STATE OF FLORIDA
DEPARTMENT OF HEALTH
ONSITE SEWAGE TREATMENT AND DISPOSAL
SYSTEM
APPLICATION FOR CONSTRUCTION PERMIT

PERMIT # 05-313-18

CONSTRUCTION PERMIT FOR: OSTDS Repair
APPLICANT: (Alachua County Housing Authority Lot 8)
PROPERTY ADDRESS: 13627 SW 156th Ter Archer, FL 32618
LOT: 8 BLOCK: W/P SUBDIVISION: Thistle Hills East
PROPERTY ID #: 04974-008-000 [SECTION, TOWNSHIP, RANGE, PARCEL NUMBER]
[OR TAX ID NUMBER]

From: Harris, Todd S
Sent: Thursday, May 31, 2018 1:36 PM
To: 'flsepticsolutions@yahoo.com'
Subject: 05-313-18 Lot 8 TH East

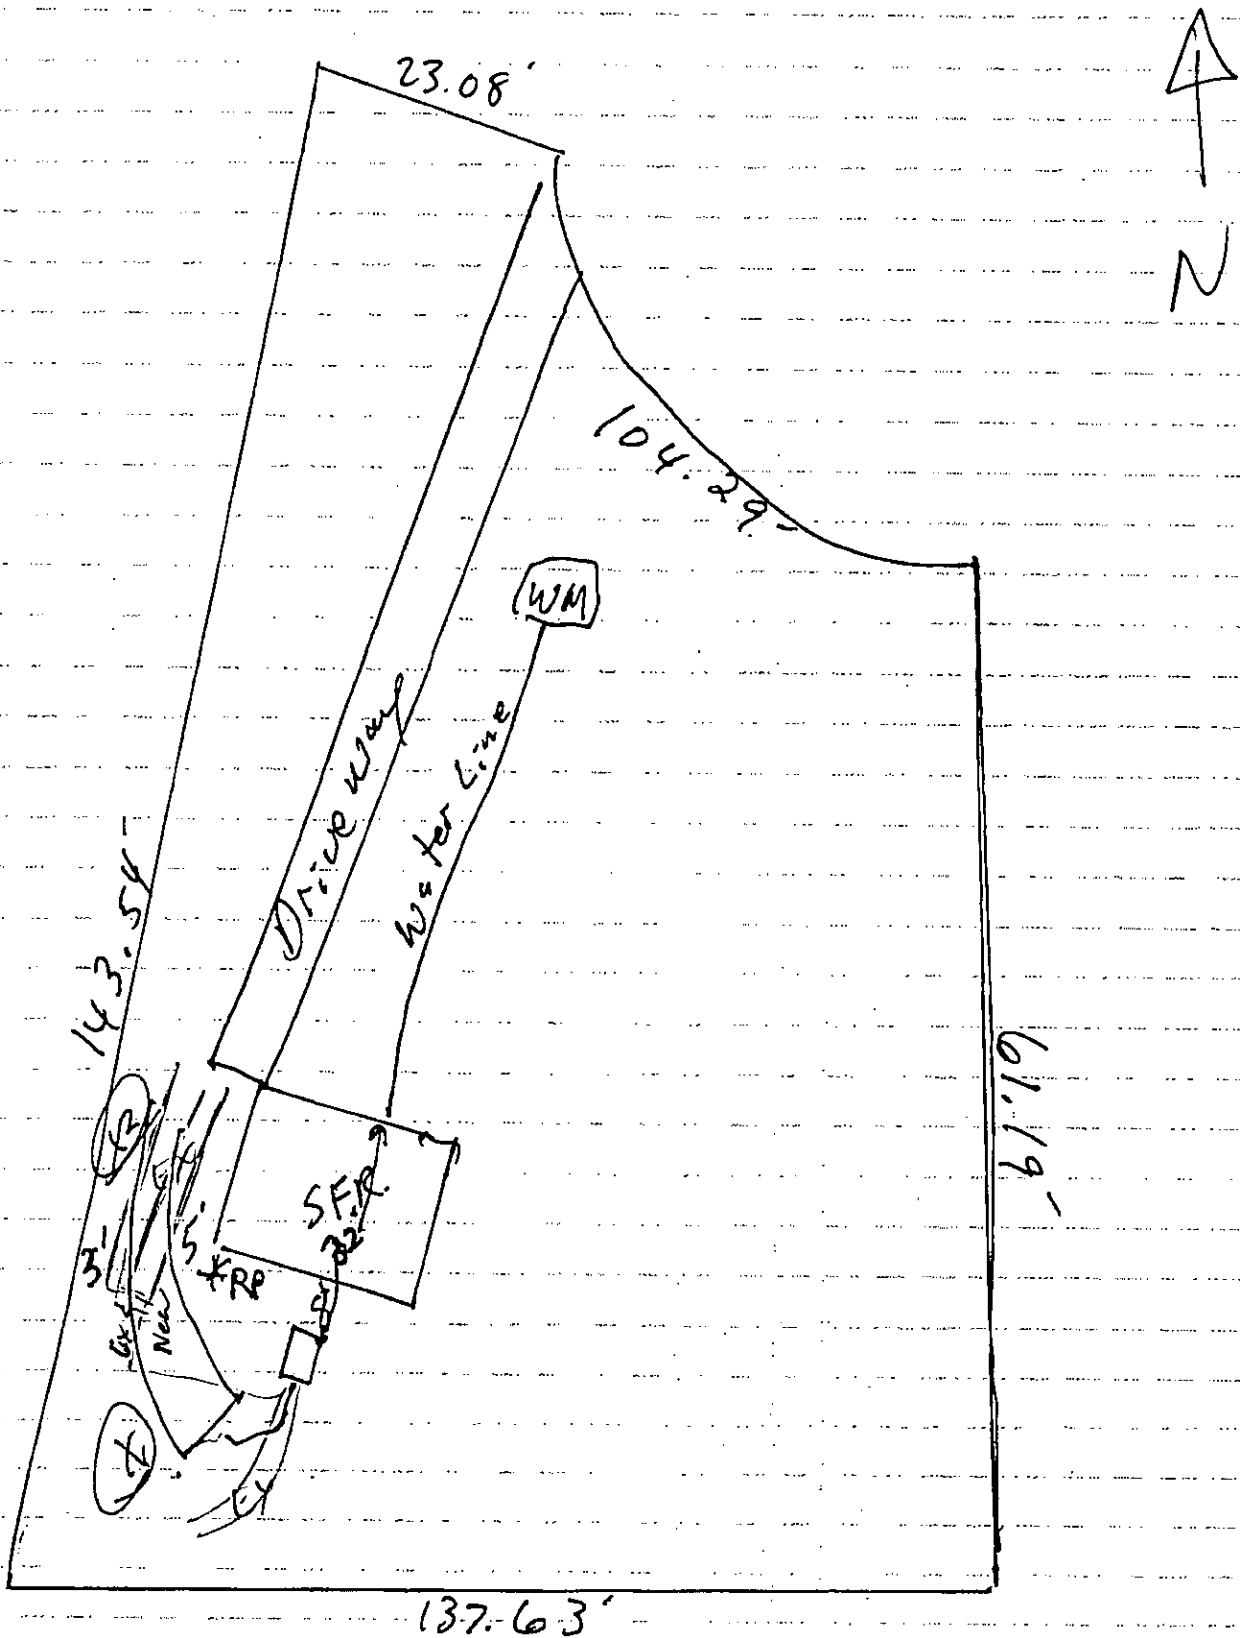
- ~~Acreage listed is double actual lot size~~
 - ~~Any associated calcs need revision~~
- ~~Appears sizing should be Table VII based on SP I~~
 - ~~Site plan and associated calcs need revision~~
- ~~Existing drainfield needs to be shown on site plan and per prior approval would be where replacement is proposed~~
 - 300 ft2 installed in 2012
 - Is age still a cause of failure?
 - Adjust all permit plans or calcs to account correct drainfield amount
- Excavation of 58" below grade based on what?
